**CHANGE
ORDER**

PROJECT:
 Bellaire Blvd. from 1464 to San Pablo Drive Paving
 and Drainage Improvements

CHANGE ORDER NUMBER 04
 DATE 4/04/2018
 PROJECT NUMBER 13202
 CONTRACT FOR 3,772,635.08
 CONTRACT DATE 3/28/2017
 FBC PURCHASE ORDER NO 151499

CHANGE ORDER REQUEST #4

DATE: 07-01-2018	BY: J.C.M.
SHEET NO. 27 OF 54	PROJECT: JPM

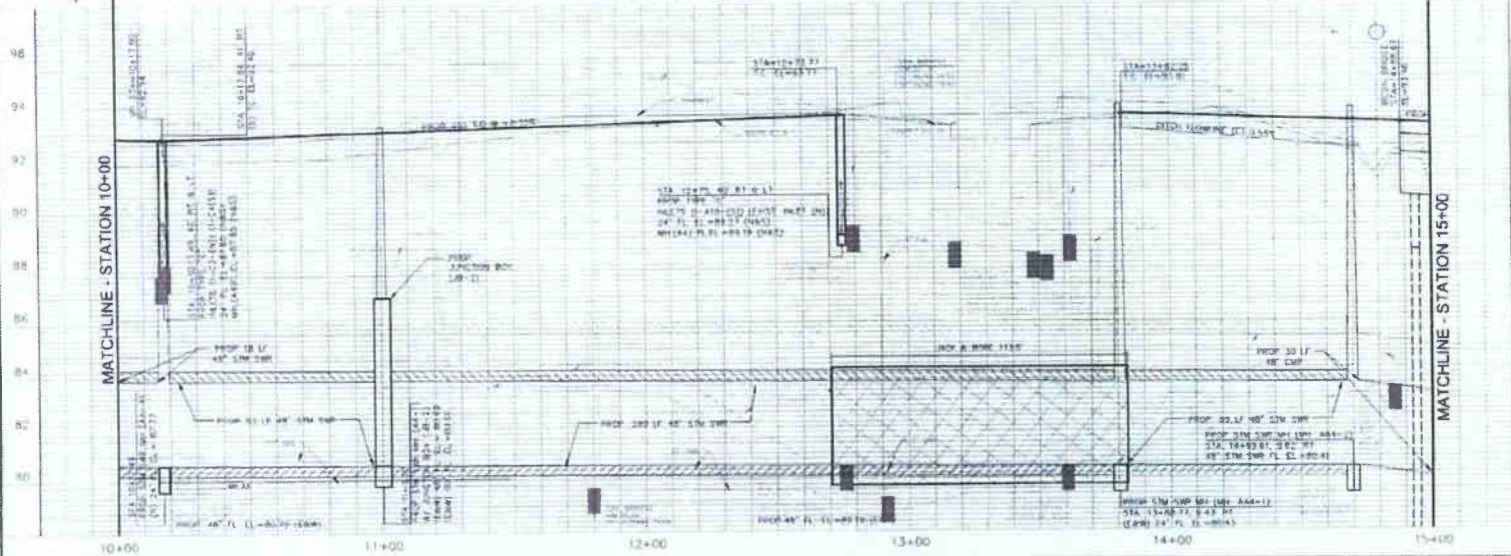
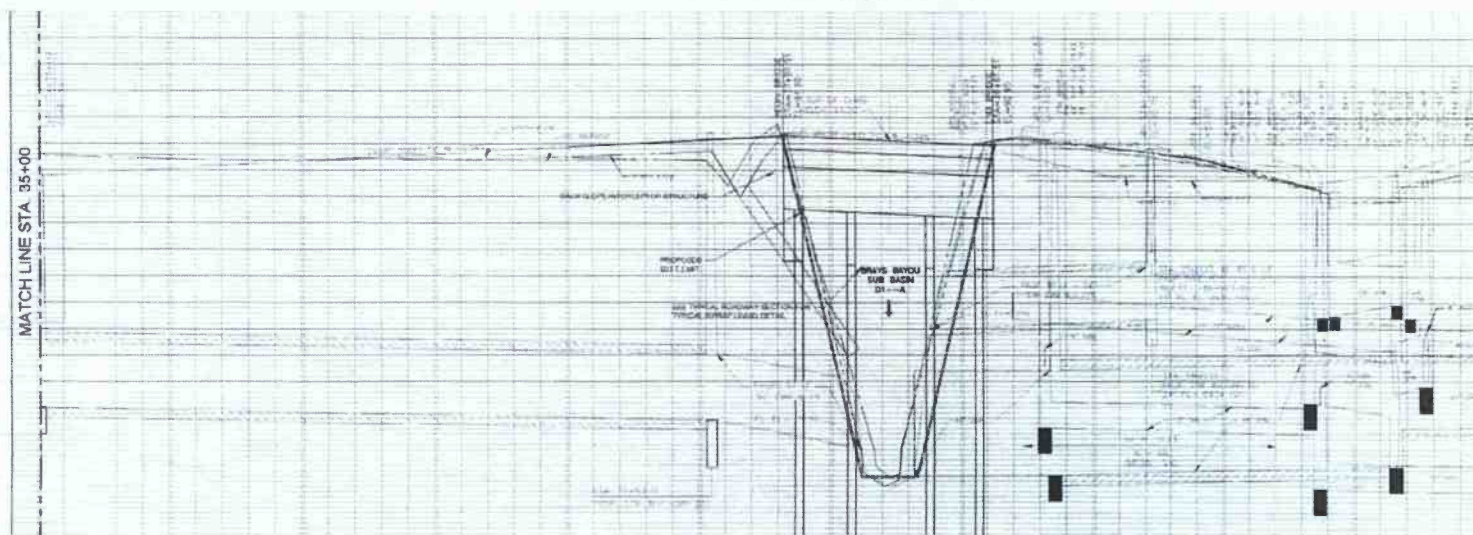
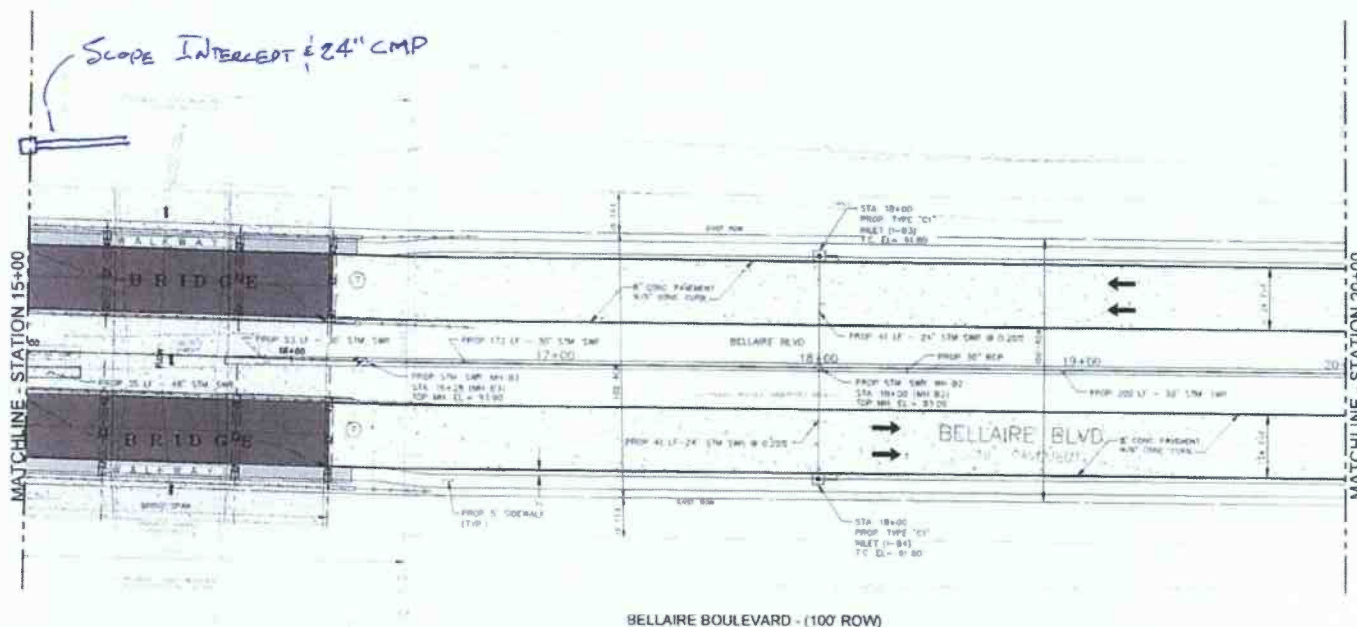
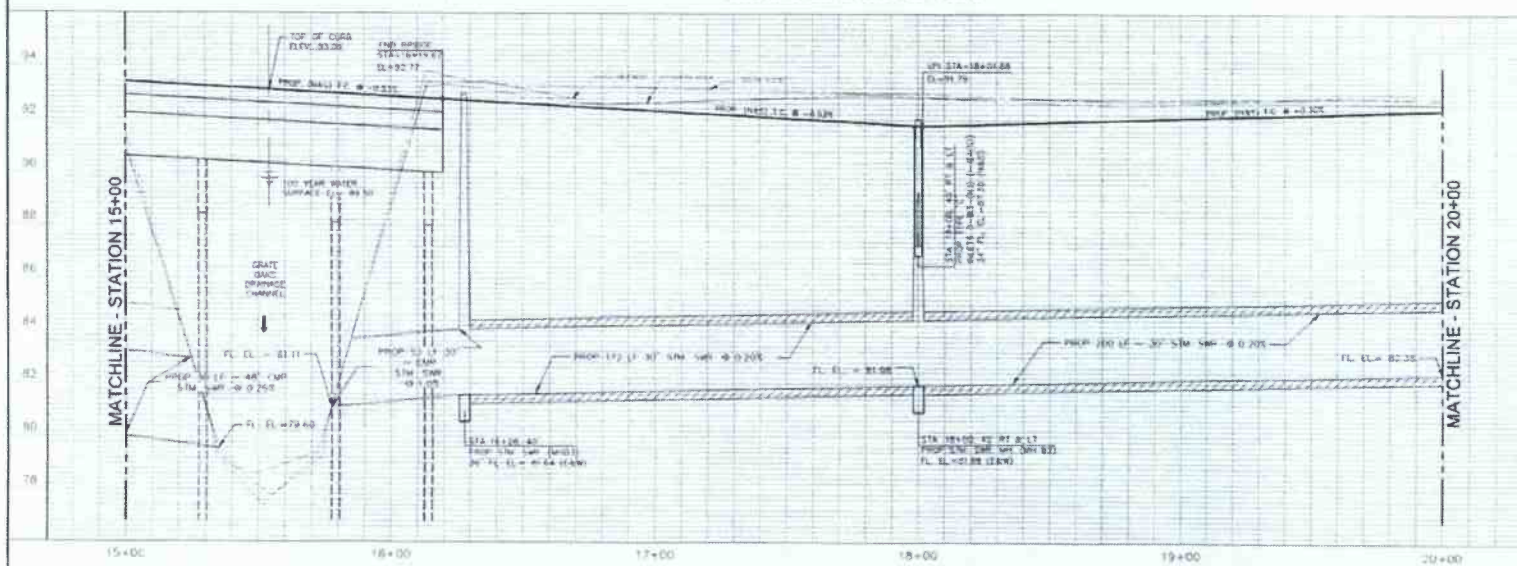
The contract is changed as follows: Add signage and stripping at San Pablo & Chickory Woods intersections per revised Sheet 52; add ramp revisions at San Pablo & Chickory Woods intersections per revised Sheet 22 & 27; add mow-strip at 8 guardrail locations and 8" crushed rock for maintenance access per revised sheet 27; extend pedestrian rail 10 lf at both locations on the west side of the San Pablo Bridge including concrete foundation revisions; add 60 lf of 24" CMP and inlet structure for drainage per revised Sheet 23; add Type A Inlet at Sta. 31+00; delete quantities not necessary to complete the work; and add 31 days to the project duration to complete the work.
